To: Technical File  
From: Dave Cline, Reclamation Hydrologist <sup>DJC</sup>  
Re: Exploration Road Stabilization Plan, Wildhorse Ridge  
Exploration Road, Beaver Creek Coal Company, CEP/015/007

Summary: On June 16, 1986 Beaver Creek Coal Company submitted NOV abatement plans for road stabilization for the Wildhorse Ridge Exploration Road. The abatement plans were reviewed in order to determine if the drainage controls submitted by the operator are technically adequate and in compliance with the regulations. After review of the plans it has been found that the plans as submitted are not technically adequate. Beaver Creeek Coal Company should be sent a deficieny letter outlining the areas that are not technically adequate along with the enclosed supporting documentation.

# Wildhorse Ridge Project

Culverts 9+10 - 24" CMP

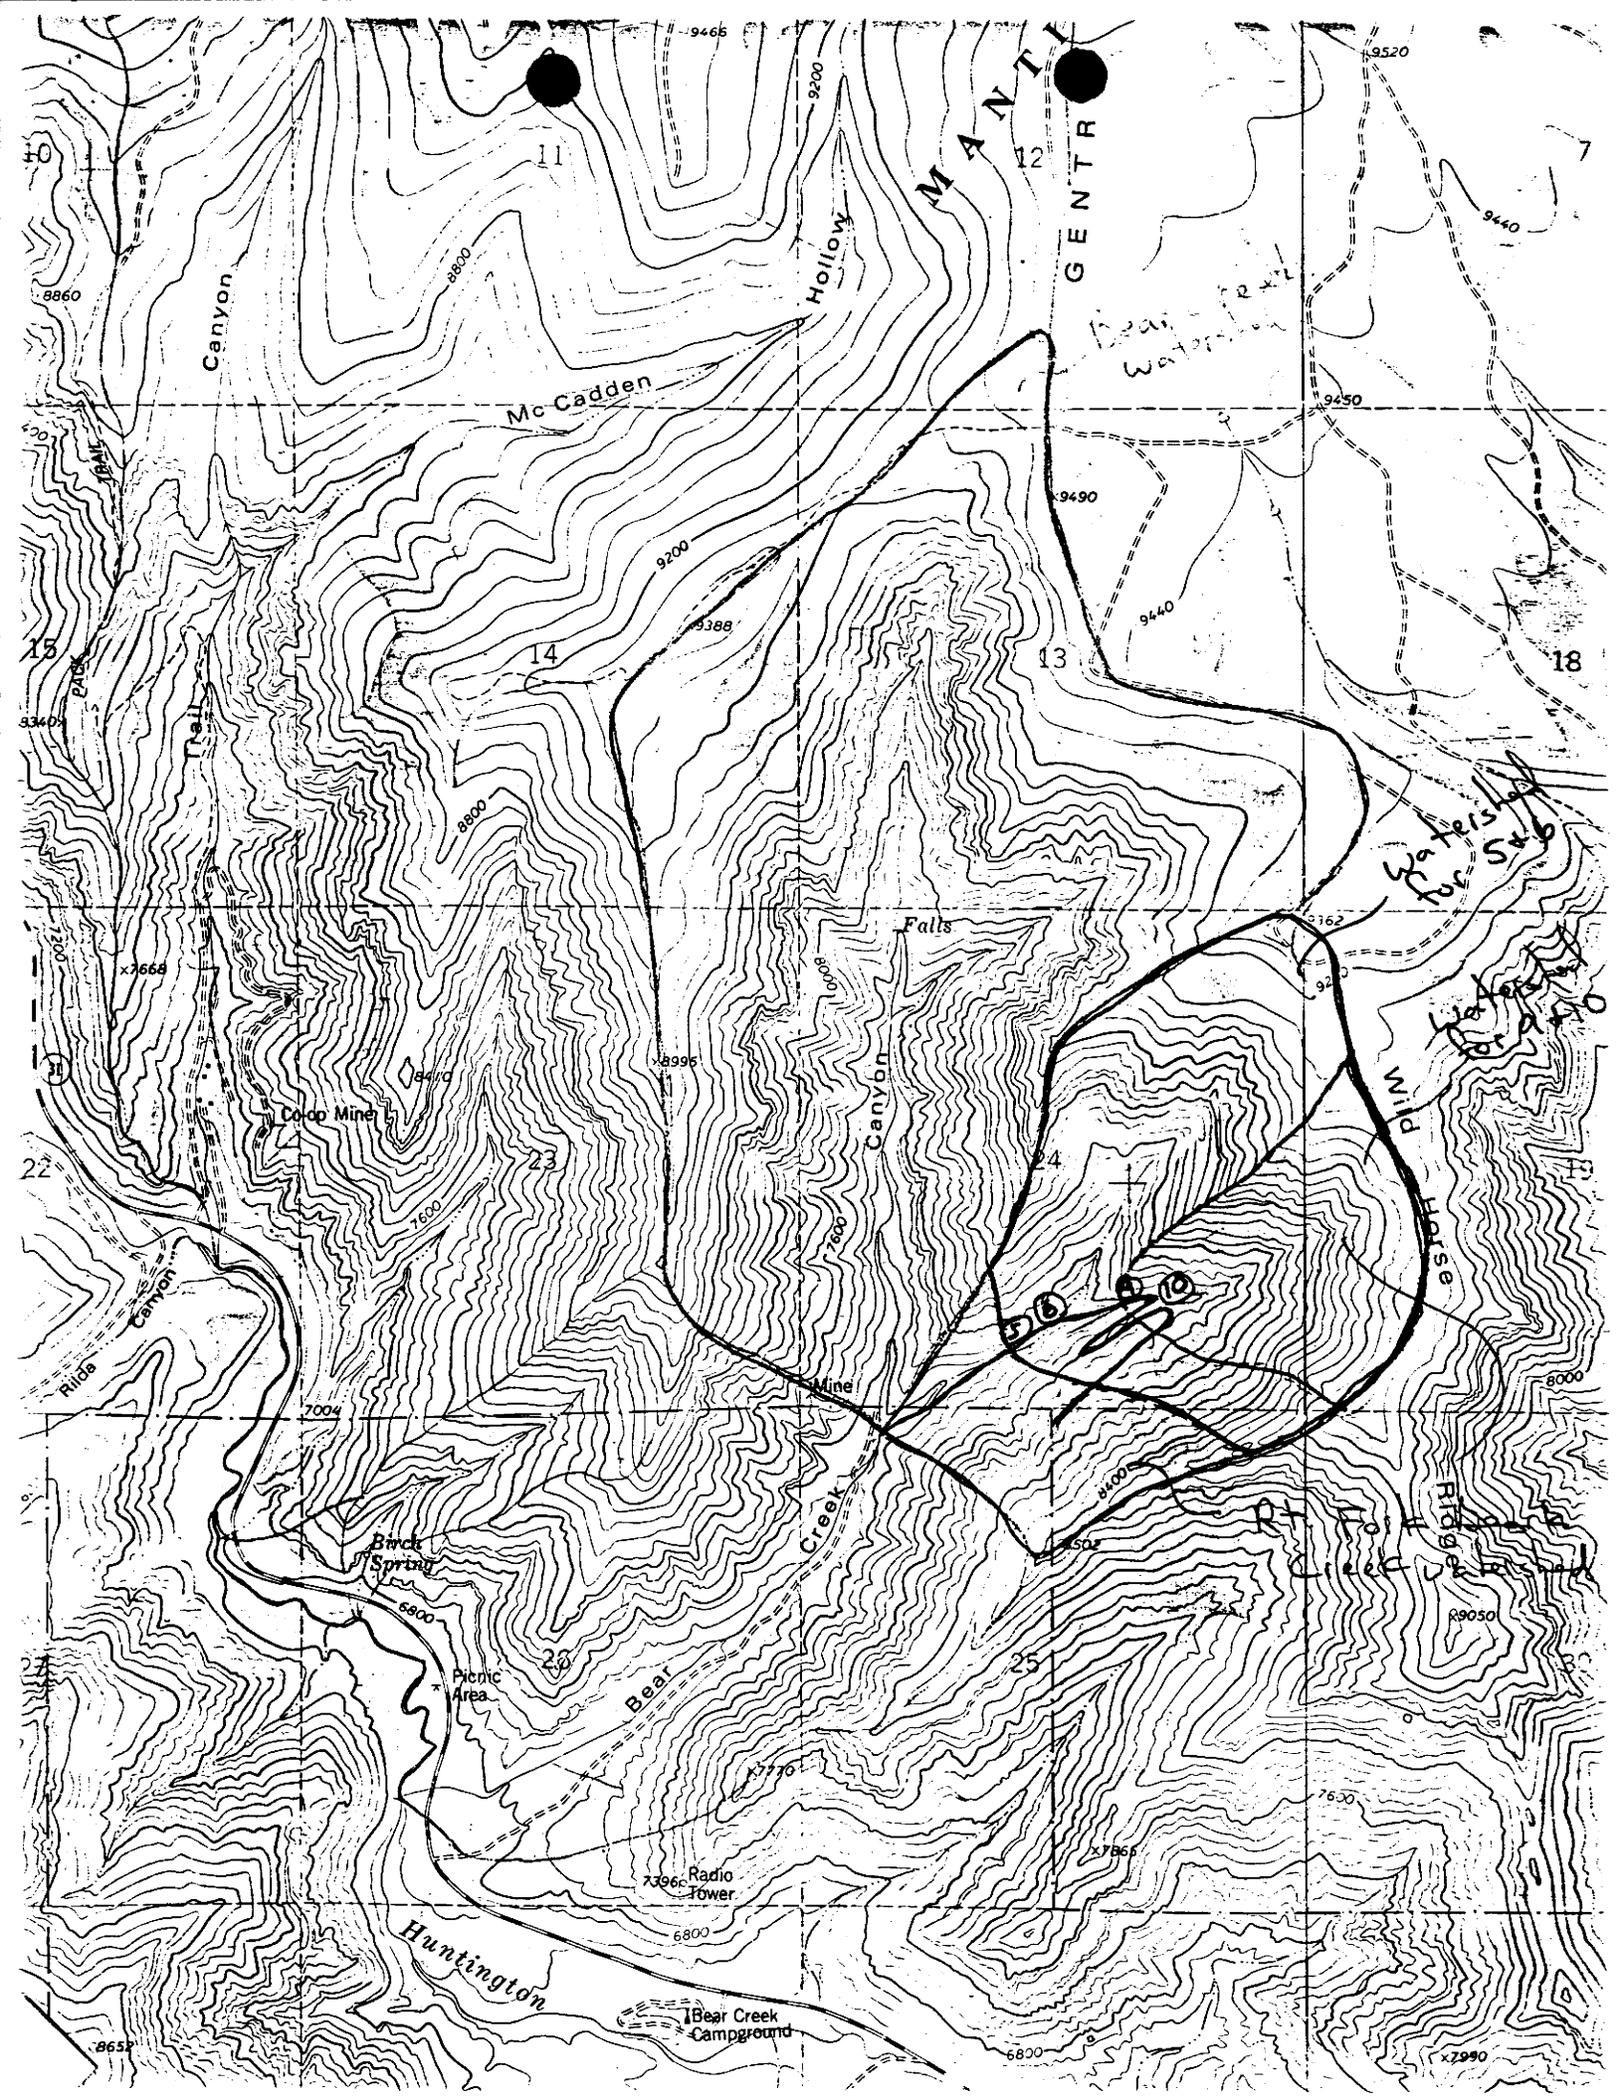
24" CMP is capable of passing 32.5 cfs

w/  $\frac{HW}{D} = 2.6$  in HW must be 5.2  
or 3.2 feet of headwall above culvert

Culverts 5+6 - 36" CMP

36" CMP is capable of passing 82 cfs

w/  $\frac{HW}{D} = 2.4$  in HW must be 7.2  
or 4.2 feet of headwall above culvert
